I-5: N. Ashland Interchange – Green Springs Project Aesthetics Advisory Committee (AAC)

Meeting #3 Summary

February 11, 2009
11:30 a.m. – 1:30 p.m.

CONCEPTUAL DRAWINGS
BUNDLE 314 • MATERIALS FOR BRIDGE COMPONENTS • ASHLAND, OREGON

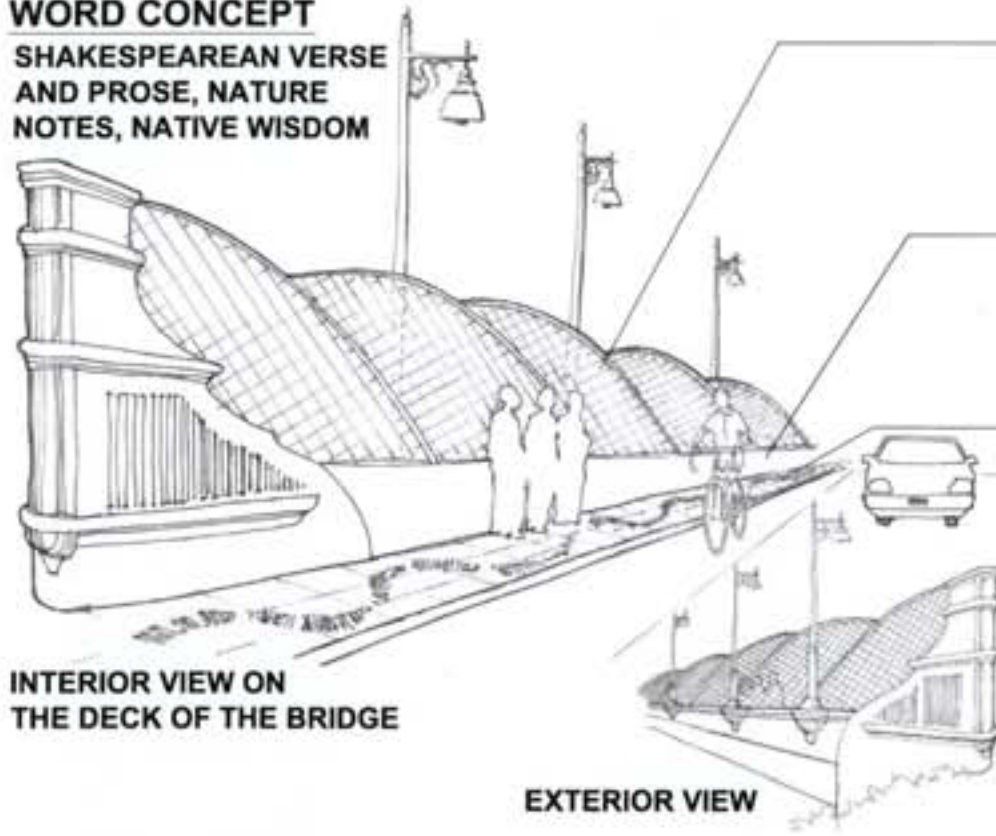
- Possibility for mosaics on the interior of the bridge using cement and steel. Panels could show relief.
- Words stamped into the concrete pedestrian path could evoke Shakespeare.

- Think of ways to showcase buildings and architecture from Shakespeare period – Lines that depict buildings?
- Bridge architecture should be simple and clean. The cleaner the lines, the more visually appealing it will be.

- Colors should reflect the natural tones of the area.
- Use of form liner should be limited to natural rock look.
- Being able to observe different bridge aesthetics will vary depending on the speed and location of the user – vehicles' view will be different than people walking.

- Sculpture at the ramp ends on each end of the bridge. Perhaps light the sculpture.
- Cor-ten steel (rebar) in the railings could match cor-ten guard rail.

CONCEPTUAL DRAWINGS

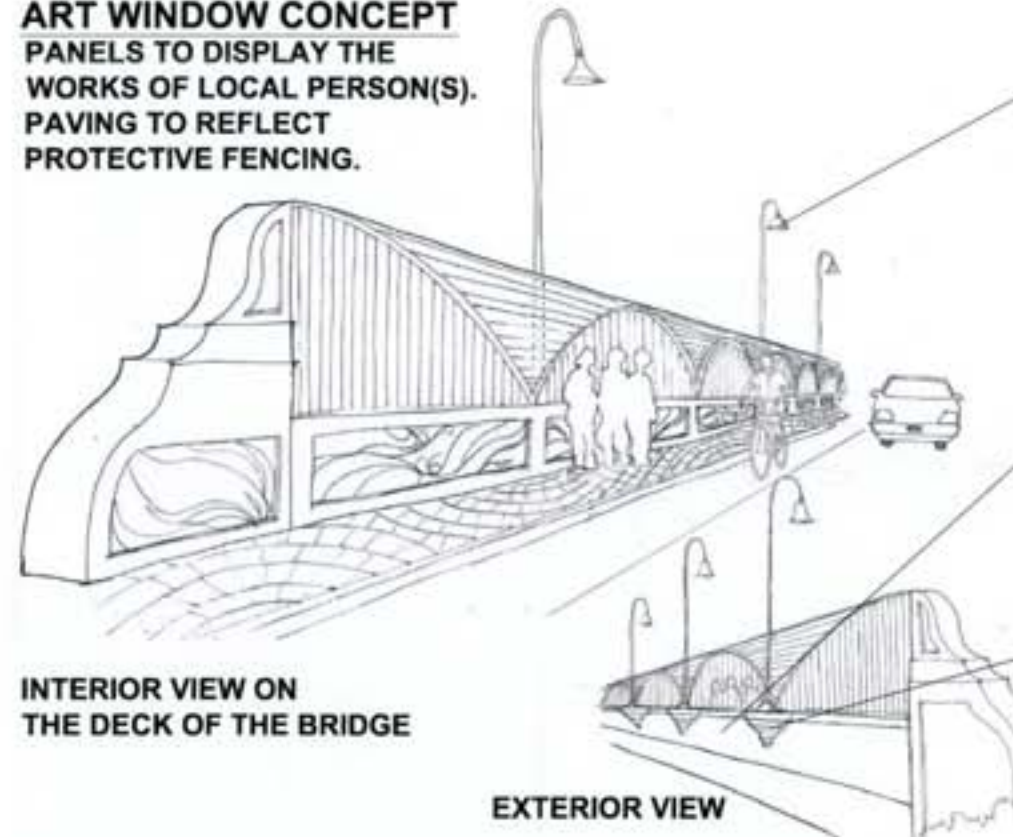
- A higher concrete pedestrian wall would better protect from the wind than a steel railing. Could we make the parapet higher than minimum standard? (Probably, but there would be a trade-off with the views/visual interest if the wall were higher. Quincy will need to consider how much higher that concrete railing can be. On a bridge widening, the weight of the railing on the bridge can be a factor and there may be maximum height due to the weight on the edge of the bridge.

- Avoid replicating the surrounding hills and mountains in the pedestrian railing – we have that naturally. Straight lines in the railing would look better – with a flat top.

- Consider the use of banners on the bridge. Flag supports could be built into the railing. The City could provide the banners and change them seasonally.

- Consider low-level lighting inset into the wall to illuminate the pedestrian path. Could this be a replacement for pedestrian lighting on poles (Unsure – will need to look into pedestrian lighting standards). If not, consider path lighting in addition to overhead. Try to match pedestrian lighting with roadway lighting.
